Re: Supplemental Report for Hillview Drive Slope Repair
Vista Tassajara, Danville, California
SFB Project No.: 768-1

In accordance with the request of the Vista Tassajara Homeowners Association, Stevens, Ferrone & Bailey Engineering Company, Inc. (SFB) has prepared this supplemental report in order to respond to review comments prepared by Cal Engineering & Geology (CEG) in their letter addressed to the Town of Danville, dated June 29, 2017. Previously, SFB prepared a geotechnical engineering report dated June 5, 2017 and also prepared hillside repair plans dated June 2017. Our responses to the CEG comments are listed below in accordance with the numbering system used by CEG in their letter. The information, opinions, conclusions, and recommendations presented below are meant to supplement our previous report dated June 5, 2017; all previous recommendations, conditions, and limitations apply.

FIGURE
2

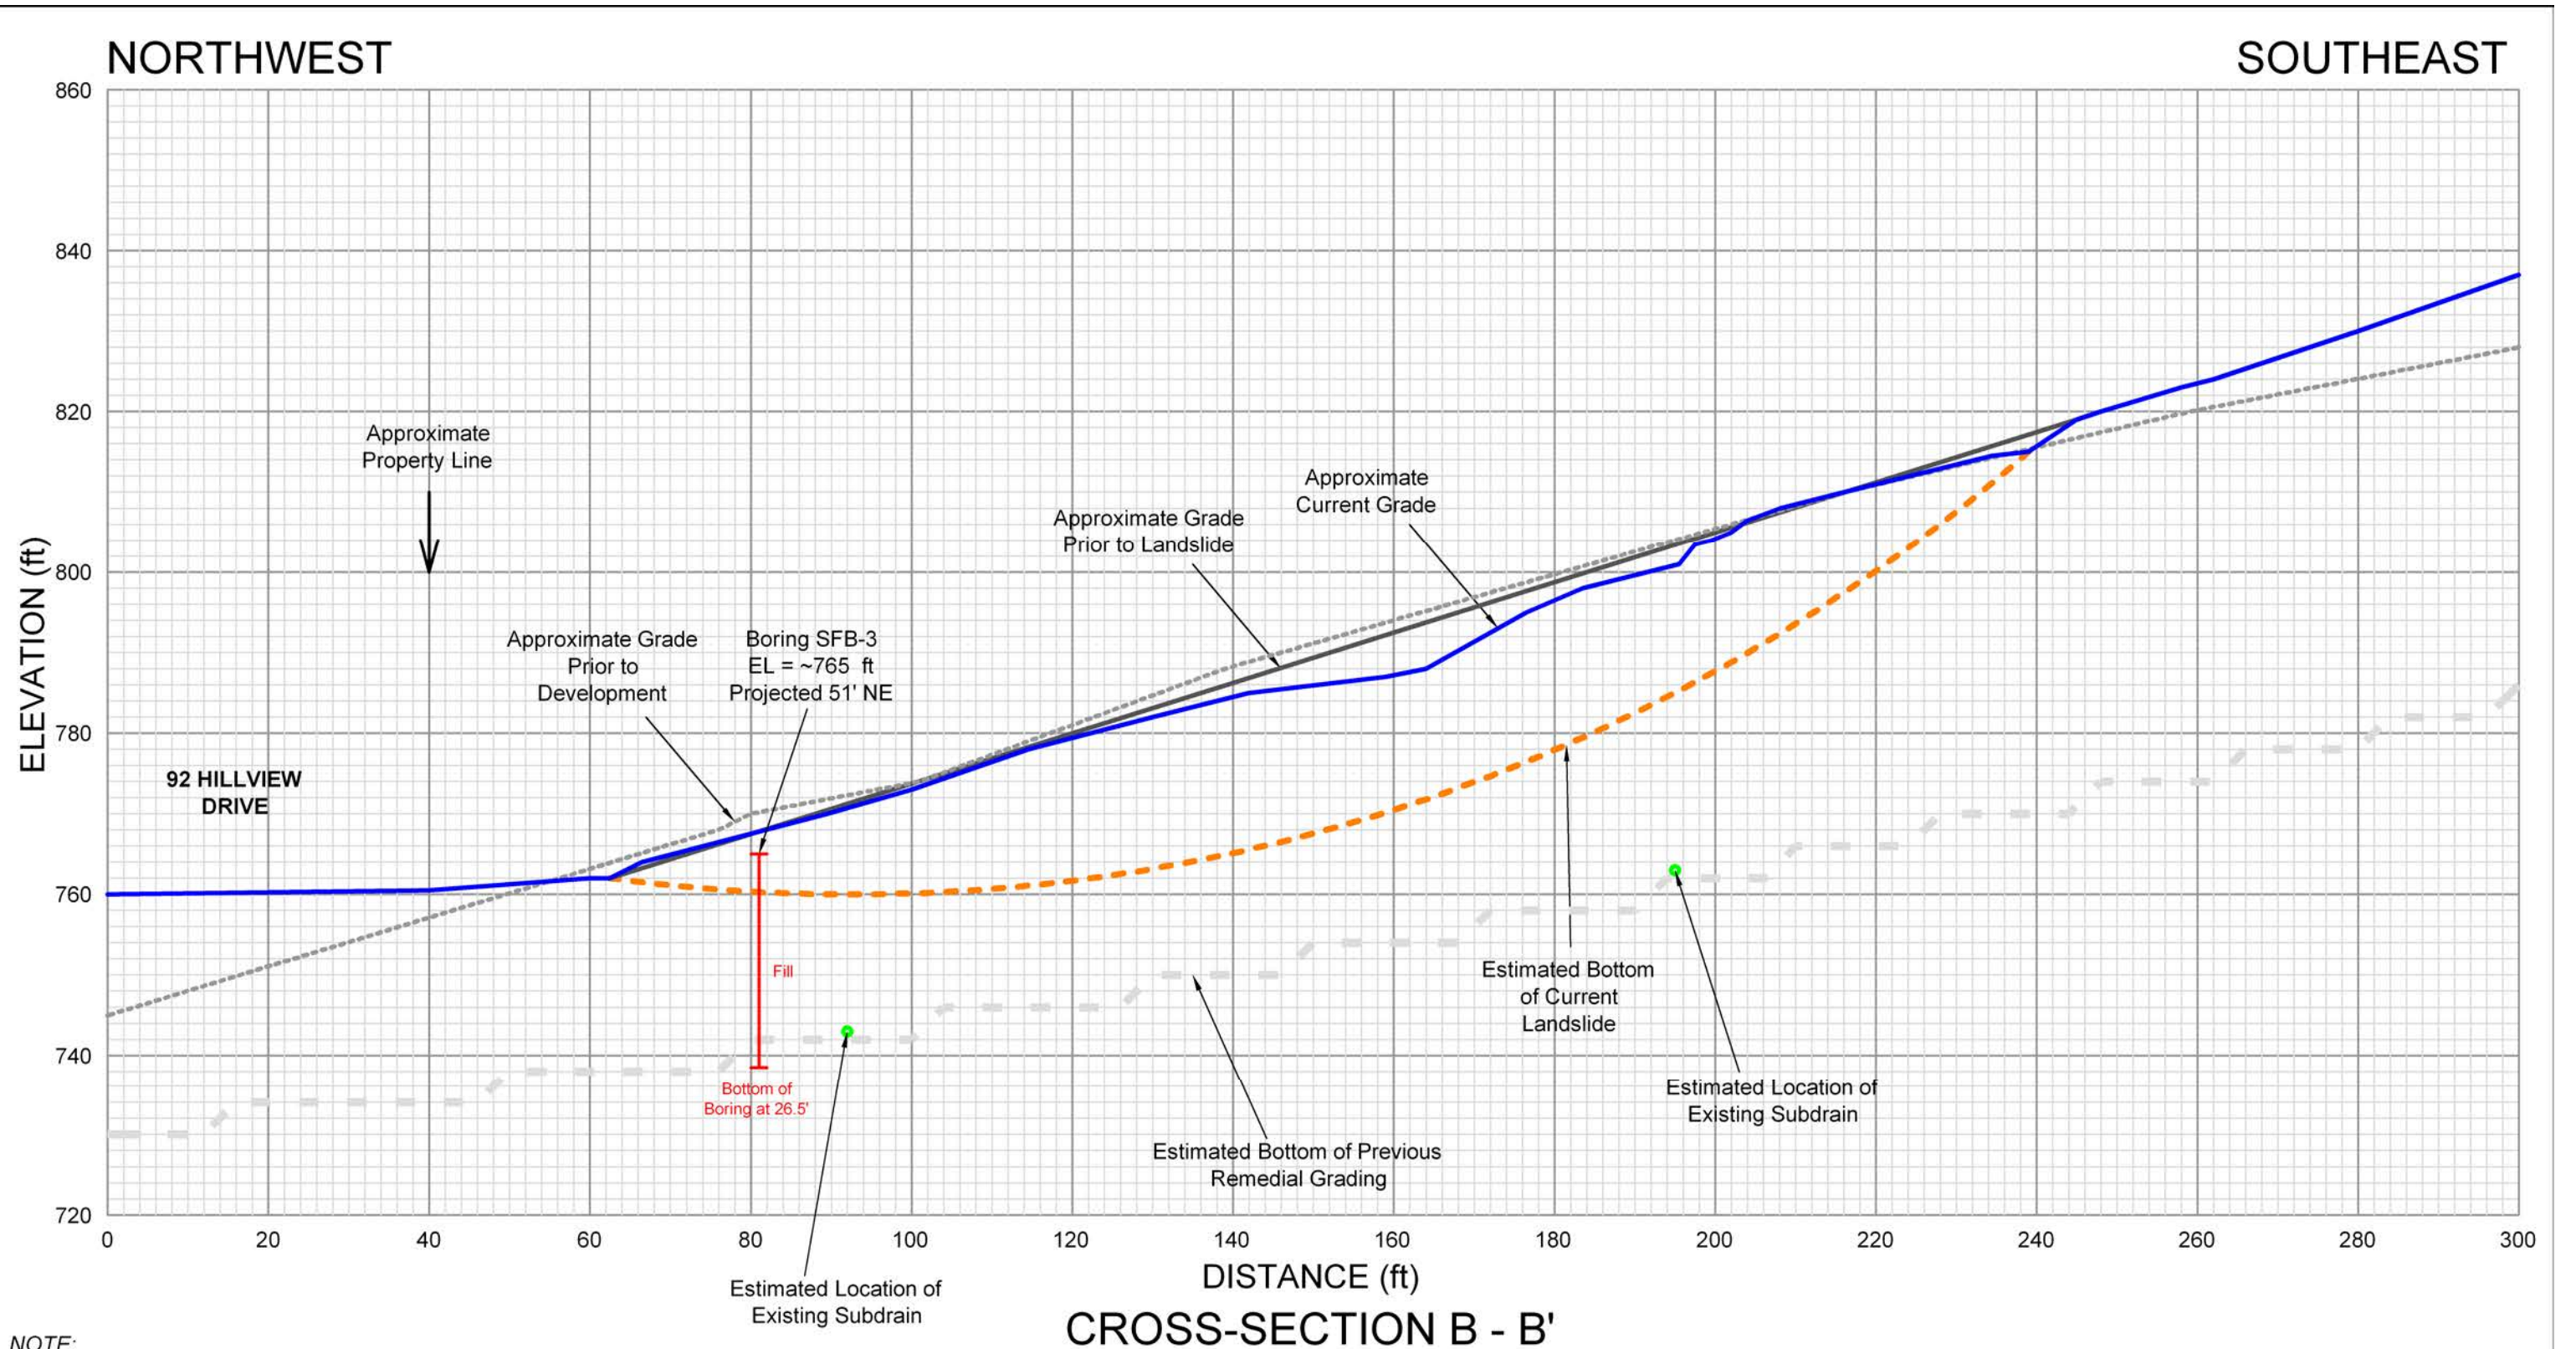
CEG Comment 3 Response: The 1988 subdrains are shown on the attached Figure 1 (Site Plan) and the attached Figures 2 and 3 (Cross-Sections). The 1988 as-built subdrain plan only shows the approximate plan view of the subdrains and does not show at what elevations the subdrains are located. Based on our understanding of the Berlogar Geotechnical Consultants (BGC) report for the 1988 grading project, the subdrains were to be placed at the bottom of over-excavations and keyways. In the area of the Hillview Drive landslide repair project, the 1988 subdrains therefore should be located at the interface between bedrock and the 1988 fill materials. Our interpreted depths (based on BGC reports) of over-excavation performed in 1988 are shown on our cross-sections in our previous report and on Sheet 5 of the plans. We don't anticipate encountering any of the 1988 subdrains since the current landslide has occurred within the existing fill materials as shown on our cross-sections. If any of the 1988 subdrains are encountered, the encountered 1988 subdrains will be properly connected to a drainage system so that they can continue to function. This task will be added to the project plans as a remedial slope grading note on Sheet 1. As shown on Sheet 6 of the plans, the lowermost subdrain is planned to discharge at the existing concrete v-ditch located in the open space area to the west of the landslide repair site (see plan sheet 2 for a view of the v-ditch). The elevation of the lowermost subdrain discharge location is at approximately 730 feet, significantly lower than the planned lowermost keyway/subdrain elevation of 750 feet at the repair site.

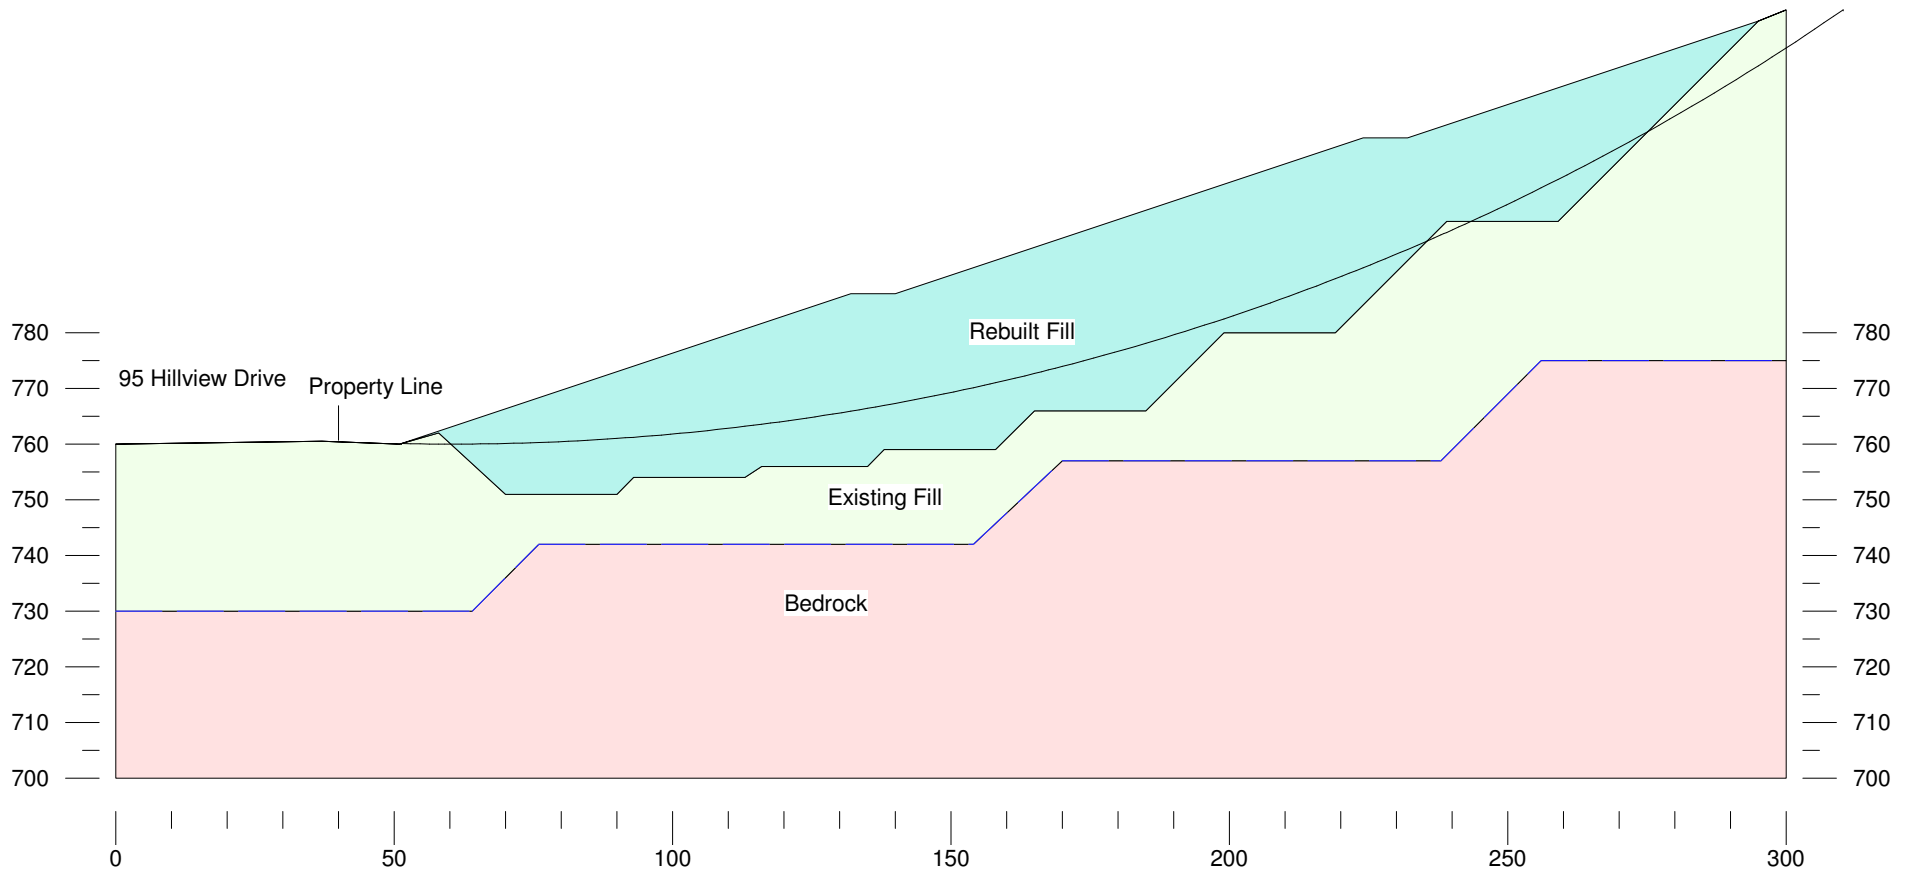
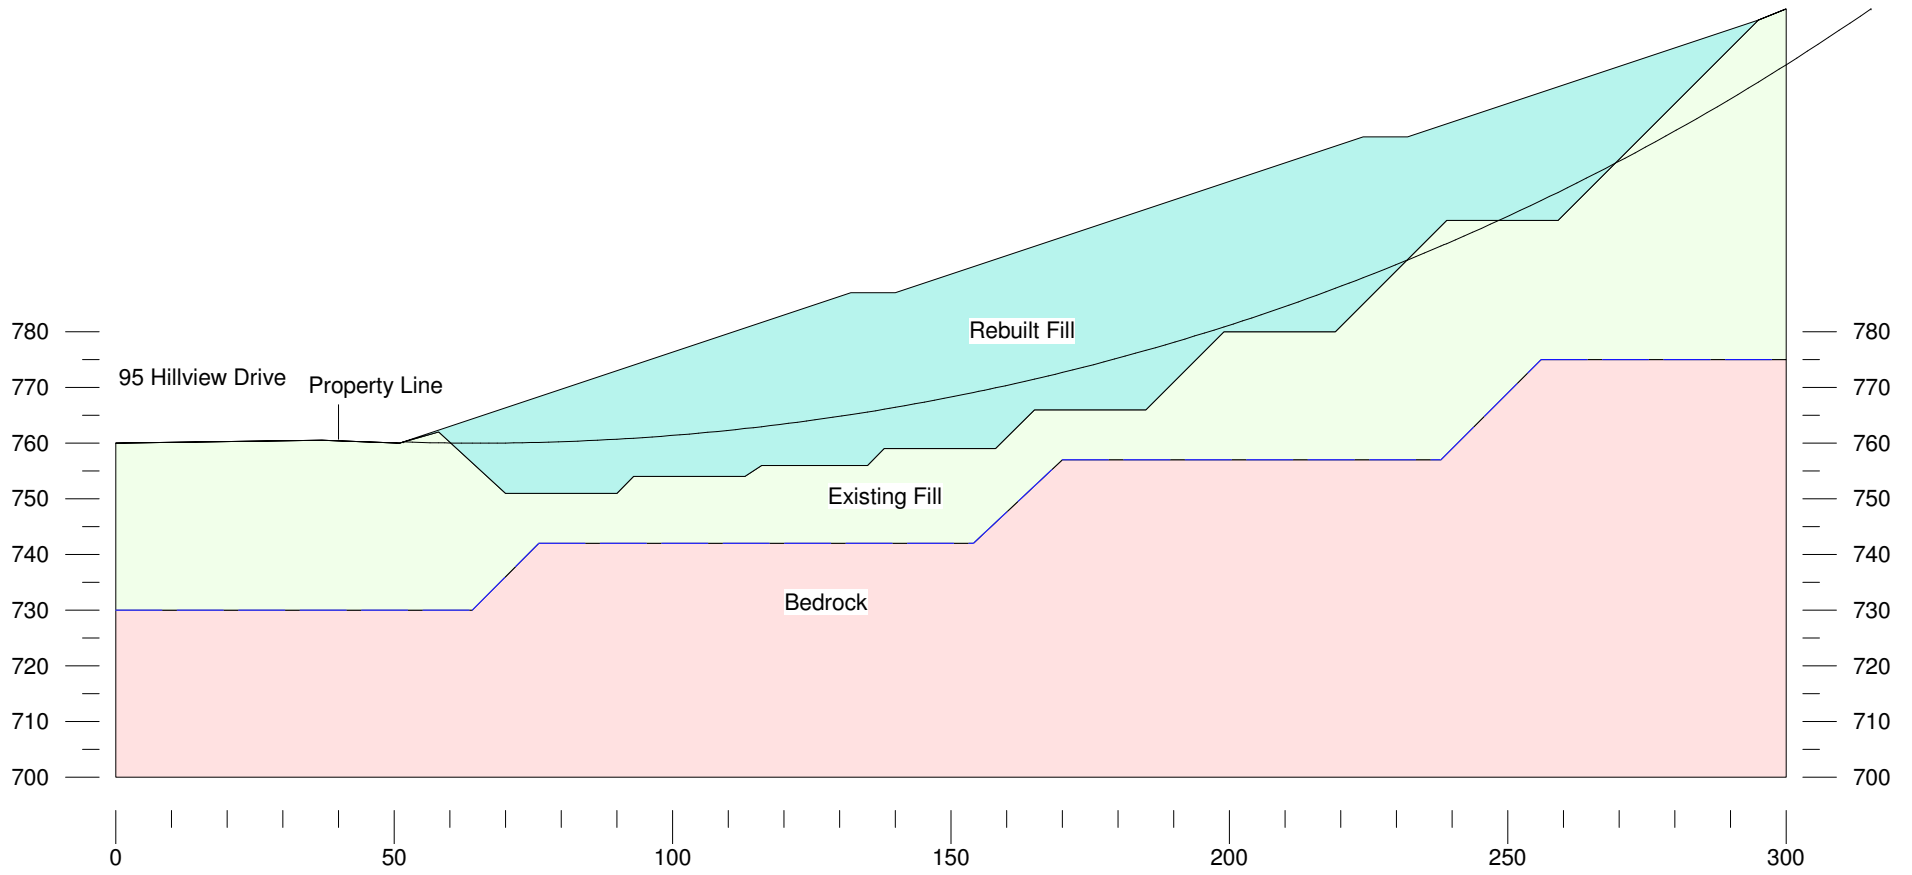
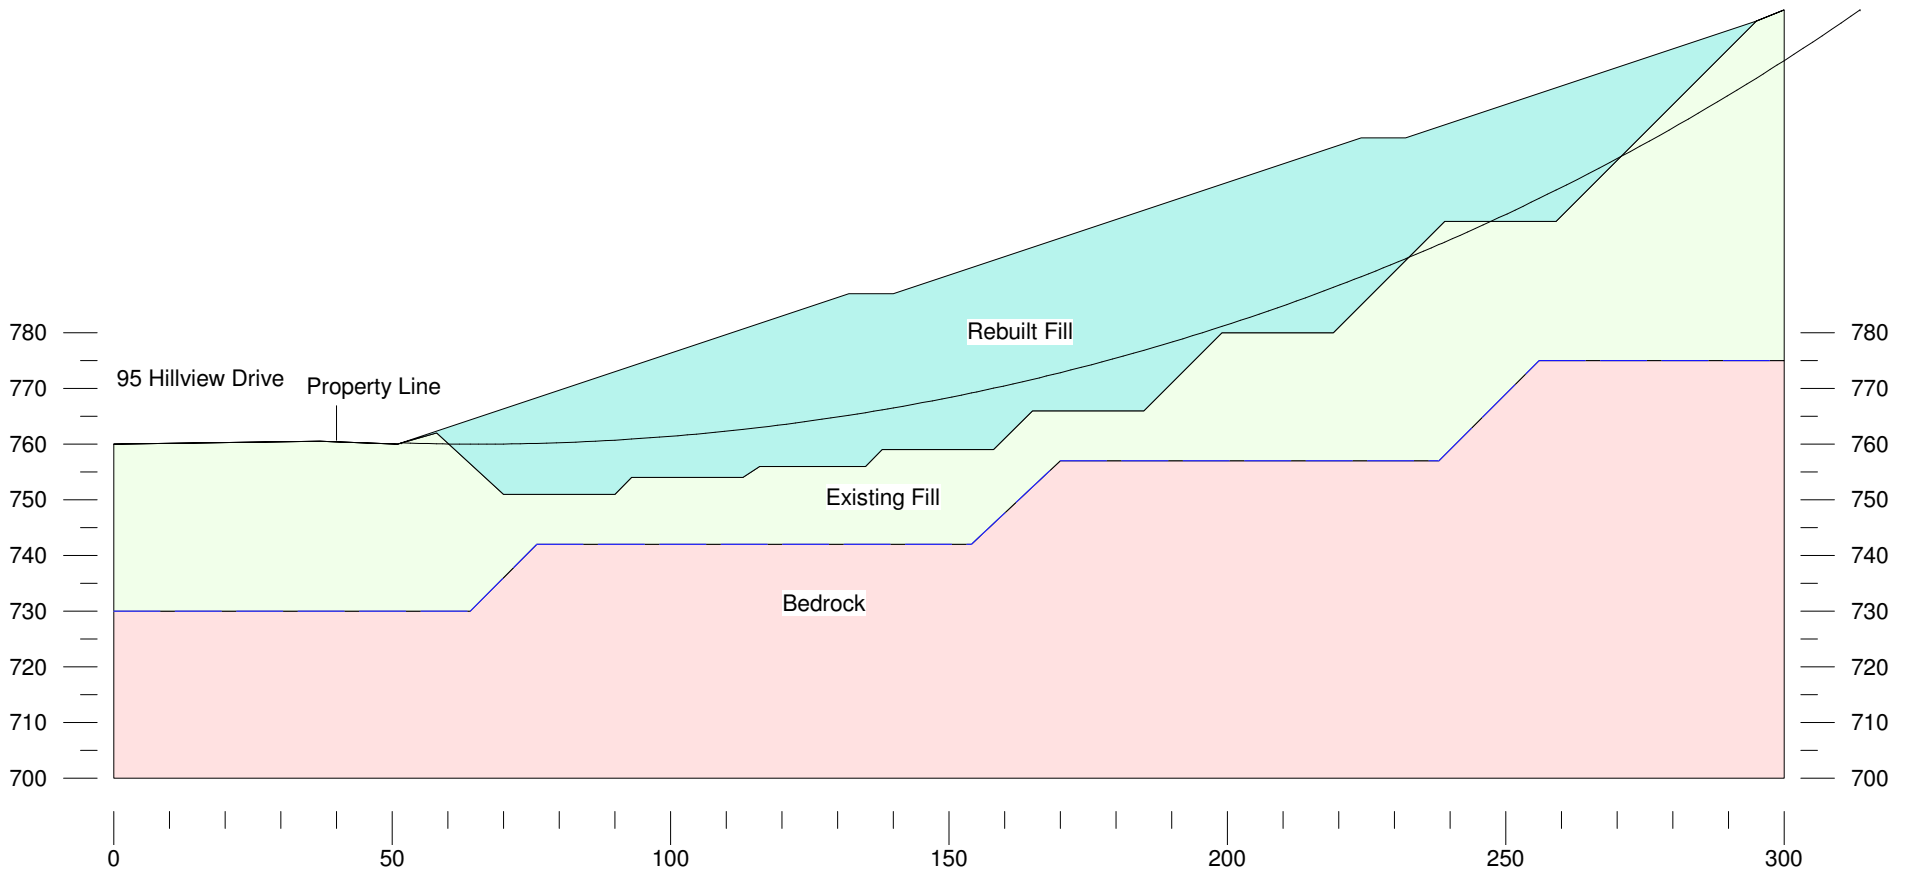
In order to directly respond to the last sentence of CEG Comment 1, we performed additional slope stability analyses assuming groundwater is located at the existing fill/bedrock interface (which assumes the 1988 subdrains are present and functional). We do not have any information to suggest that the 1988 subdrains are not present or not functional. By placing the groundwater surface at this interface, this condition results in the bedrock being affected by groundwater induced pore water pressures. The results of this slope stability condition analysis are attached in Appendix A. The static factor of safety in this case is 1.87 and the seismic factor of safety in this case is 0.96 which represents the slope performance index when the slope is subjected to a major earthquake (as explained above).

For comparison purposes, we performed additional slope stability analyses using the generally accepted Seed procedure (by apply a seismic coefficient $k = 0.15$). The table below summarizes the most critical results of our slope stability analyses of the proposed slope repair grading along Section a - a' under both static and pseudo-static conditions. The results of the additional slope stability analyses (as requested by CEG) are included in the table for comparison. The result of this analysis is presented in the attached **Appendix A**.

Cross-Section a-a'	Factor of Safety against Sliding		
	Static	Pseudo-Static (Earthquake Loading $k = 0.25$)	Seed Procedure Pseudo-Static (Earthquake Loading $k = 0.15$)
Proposed Slope Repair (Groundwater at Fill/Bedrock Interface)	1.87	0.96	1.20

The results of our supplemental analyses using the Seed procedure indicates that the factor of safety against sliding for the case where groundwater is located at the fill/bedrock interface is greater than the generally acceptable value of 1.15 when applying a Seed seismic coefficient of 0.15.
